MANDATORY SERVICE BULLETIN MSB 42-126/1 MSB 42NG-066/1

SUPERSEDES MSB 42-126 and MSB 42NG-066

Inspection of flap bell crank for cracks, installation of two spacers instead of one long spacer and replacement of early revisions of the affected flap bell crank.

WORK INSTRUCTION WI-MSB 42-126 WI-MSB 42NG-066

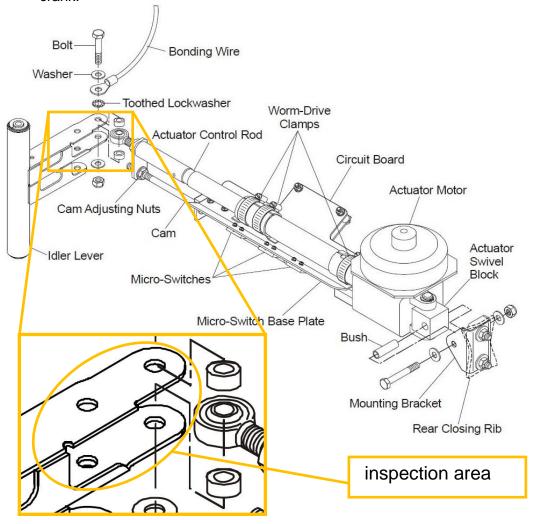
If flap bell crank D60-2757-11-00 revision "e" or "f" is installed:

- Examine the flap bell crank for cracks and deformation in the area where the flap pushrods are attached to the flap bell crank as shown in the figure below.
- If cracks or deformation are found, replace the flap bell crank with the improved flap bell crank D60-2757-11-00 01 in accordance with AMM, Section 27-50.

Note: In case of doubt remove the powder coating and carry out dye penetration method to identify possible cracks.

Note: Apply epoxy based zinc phosphate primer and commercial grade 2K PU lacquer to areas where the powder coating has been removed or has been damaged.
